Board of Zoning Adjustment for the District of Columbia

Summary of Case

BZA 18980 – 1636 Argonne Place NW – Submitted 5/4/15 – Resubmitted 5/5/15

2014 Plat with Proposed Lot Occupancy and FAR Calculations

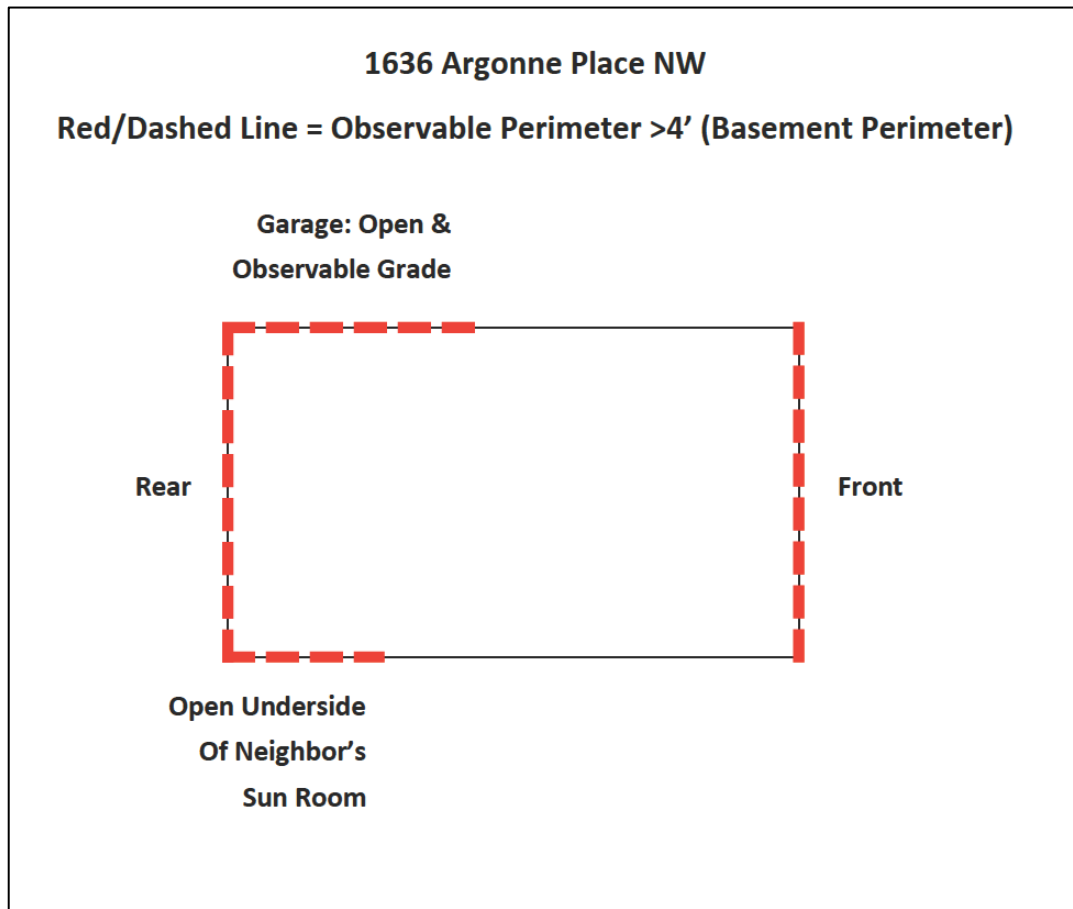
Corrections on Proposed Lot Occupancy and FAR Calculations

Proposed	2014 Plat	Actual
Lot Occupancy		
2014 Plat: First Floor w/o porch <u>Actual</u> : Lower Level w/o lower level entryway	45 x 20 = 900	44.46 x 20.48 = 910.46
Porch	7.1 x 11.2 = 93.72	7.10 x 14.42 = 102.41
<u>Actual</u> : Lower level entryway to be enclosed (not within footprint of above porch)		7.1 x 6.06 = 43.06
Total Building Area	900 + 93.72 = 993.72	910.46 + 102.41 + 43.06 = 1055.93
Lot Occupancy	994/1700 = 58%	1055.93/1700 = 62%
FAR		
Lower Level	Not Included	1067.01 From A0101 (6/24/14)
Level 1	994	1012.87 From A0101 (6/24/14)
Level 2	900	1012.91 From A0101 (6/24/14)
Level 3	855	870.36 From A0101 (6/24/14)
Mezz (Level 4)	256	300.24 From A0101 (6/24/14)
FAR	3005/1700 = 1.76 FAR	5263.38/1700 = 2.51 FAR

Revised Plans:
Dimensions of
Front Entryway
7' 1 ¼" wide

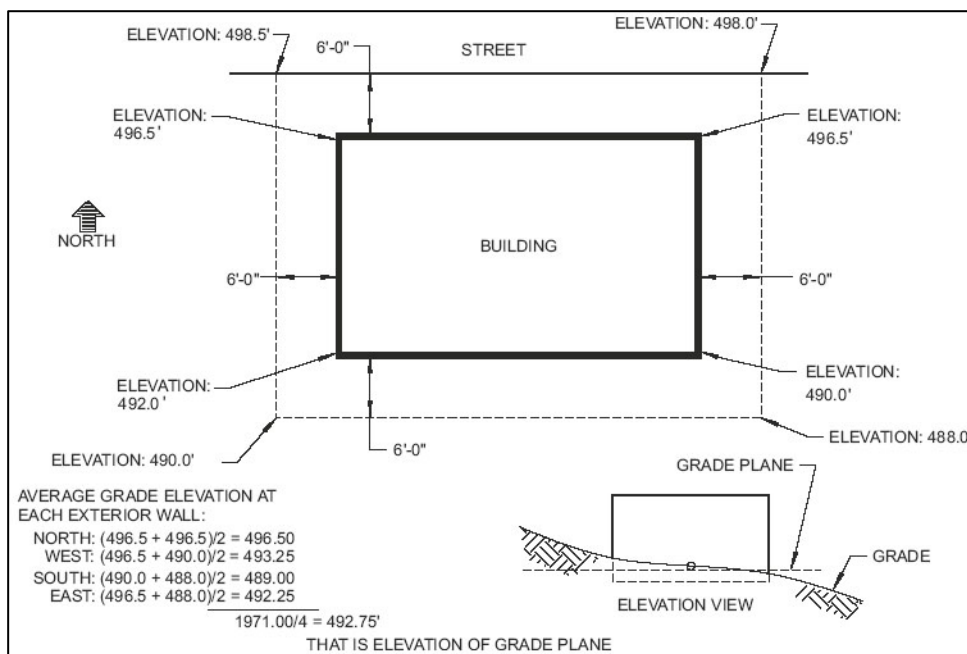
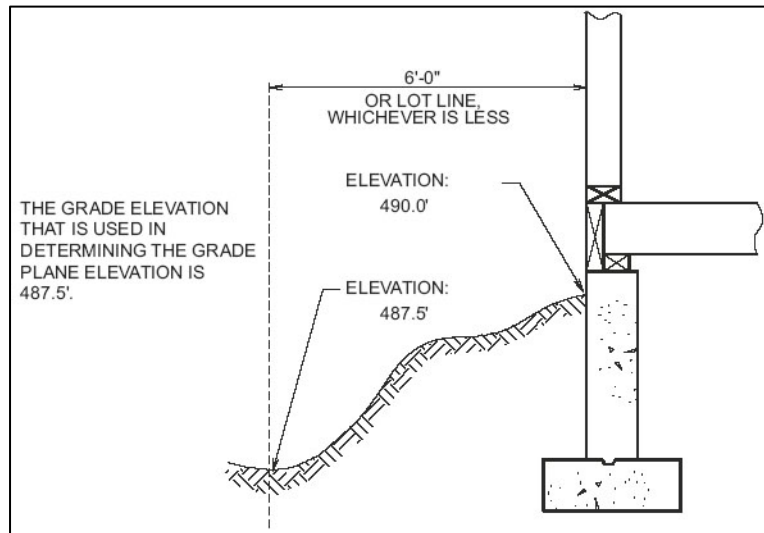
Errors in the front grade determination include the misidentification of the point of reference for the front finished grade, despite the fact that the subject property's entryway to the lower level is 7' 1 ¼" wide from the face of the building's front wall to the face of the area's retaining/exterior wall and, as such, is definable as the adjacent finished grade (see below). The standard for considering the front entryway space as the adjacent finished grade is outlined in BZA Appeal No. 18615 of 5333, Connecticut Neighborhood Coalition, et al., 10/29/13. That ruling defines the parameters of space that are not definable as the adjacent finished grade, specifically, an “areaway” that is a “generally accepted five-foot width standard” that the Zoning Administrator has “never considered” as the adjacent finished grade. In establishing the parameters for a space that is NOT DEFINABLE as adjacent finished grade (an “areaway”), the Zoning Administrator establishes, by logical extension, the parameters for a space that IS DEFINABLE as the adjacent finished grade.

- **Revised Plans: Front Entryway Grade.** Architectural plans dated 12/17/14 identify the front

grade as 3'11".. However, the front finished grade of this point is misrepresented in the plans. The actual front grade at this point is 7'6". Notably, revised plans do not correct errors identified in the initial plans.
